ITEM E4 – TERRA BELLA SUBDIVISION

KPB File # 2022-024

KPB 2022-024

KPB File No.	2022-024
Plat Committee Meeting:	April 11, 2022
Applicant / Owner:	Terra Bella Properties, LLC of Anchorage, Alaska
Surveyor:	Stephen Smith / Geovera, LLC
General Location:	West Fairview Avenue, City of Homer

TERRA BELLA SUBDIVISION

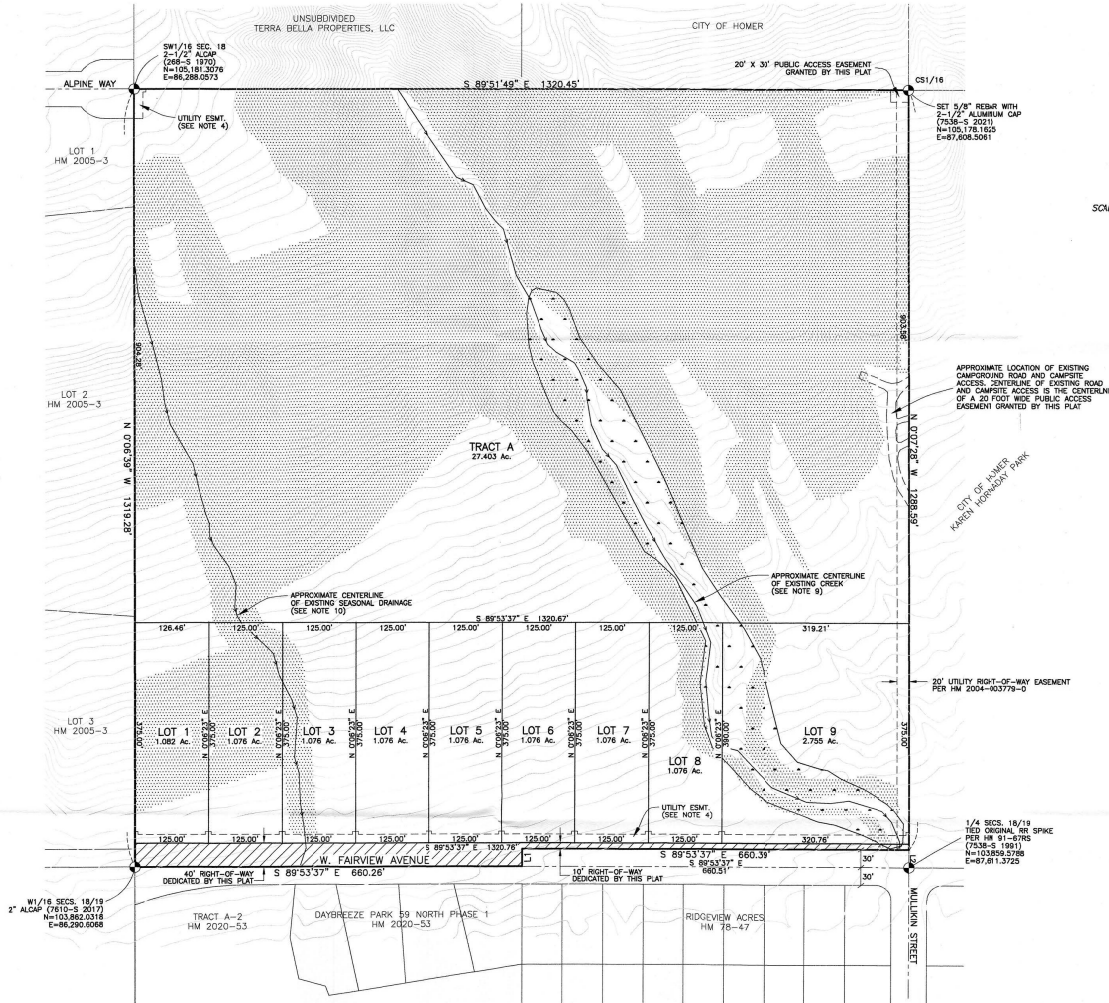
Staff recommendation: *Revise the title block by removing "A Portion" and add "excepting therefrom, Fairview Avenue according to Plat HM 88-52".*

- *We generally do not want ownership of neighboring lots as those may change. Remove "Terra Bella Properties, LLC" and "City of Homer" from lot designations and just provide "Unsubdivided".*

- *Staff would like for labeling to be consistent. The lots to the west only contain the recording number while those to the south have the subdivision name. Please either had the names to those to the west or remove on the southern lots.*

- *Provide Lot labels for the lots located south of W. Fairview Avenue.*
- *Located to the southwest is a preliminary plat that is being finalized in phases. Phase 1 has recorded and the lot should be labeled “Tract B1 HM 2022-07” and note the section line easement present for the southern portion of W Fairview Avenue. This will need to be reviewed prior to final. If Phase 2 records, it will change the Tract’s designation and W Fairview Avenue in addition to Eric Lane may be dedicated.*

- *Provide a width label for the portion of W Fairview Avenue located to the west of the subdivision and for the portion to the east.*
- *Provide width labels for Mullikin Street and Alpine Way.*

- *Per the Certificate to Plat, there is an easement for the existing water main along Fairview Avenue. The exhibit was not recorded with the easement but it appears to be within the area of Fairview Avenue. A plat note should be added, as this is on the Certificate to Plat. If the City of Homer agrees that the location will now be fully within the dedicated right of way, add to the plat note "the easement is no longer required with the dedication of W. Fairview Avenue." The other option is to work with the city to get the easement removed from the Certificate to Plat.*
